Item ID: D407-667-105TRN

Item Name: Crosstube Turning Detail

DART AEROSPACE LTD		Work Order:	129296
Description: Crosstube Assembly		Part Number:	D407-667-145
Inspection Dwg: D407-667-145 Rev: C		Page 1 of 2

DRAWING NO. D407-667-145	TITLE CROSSTUBE ASS'Y (407 HIGH FWD)	REV. C	DART AEROSPACE LTD ENGINEERING ORDER		D.E.O. NO. D407-667-145-C-2	SHEET NO. SHEET 1 OF 1	SCALE NTS
DRAWN AJS	CHECKED	MFG. APPR.	APPROVED	DE APPR.			
DATE 12.08.02	DATE 12.08.02	DATE 12.08.02	DATE 12.08.02	DATE 12.08.02	DATE 12.08.02

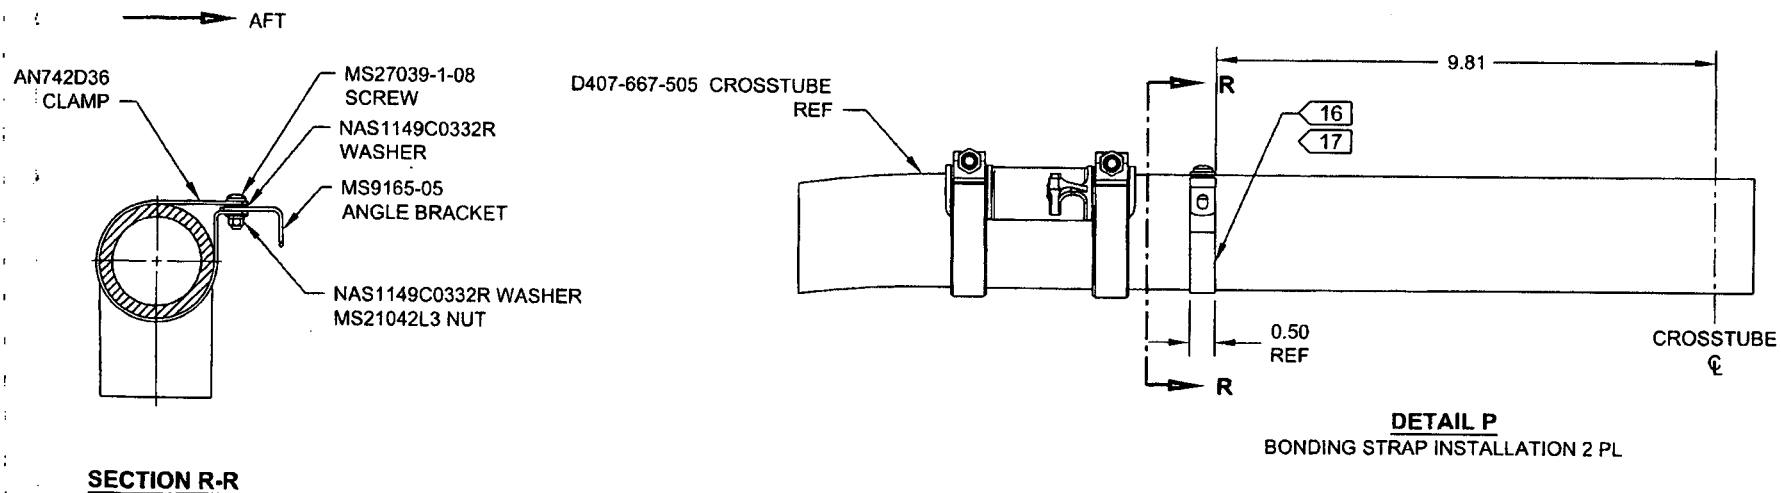
ADD ELECTRICAL GROUNDING STRAP

ITEM	QTY -145	PART NUMBER	DESCRIPTION
1	X	D407-667-145	CROSSTUBE ASSEMBLY (407 HIGH FWD)
10	2	AN742D36	CLAMP
11	2	MS9165-05	ANGLE BRACKET
12	2	MS21042L3	NUT (OR MS21042-3)
13	2	MS27039-1-08	SCREW
14	4	NAS1149C0332R	WASHER (OR AN960C10L)

- 16) MASK AREA UNDER CLAMP PRIOR TO PAINTING
- 17) SEAL EDGES WHERE AN742D36 CLAMP MEETS WITH THE CROSSTUBE USING SIKAFLEX-241/-291 OR MIL-S-8802 CLASS B2 OR PROSEAL 890 SEALANT
- 18) PERFORM RESISTANCE CHECK TO ENSURE MAX RESISTANCE IS 10 MILLIOHMS
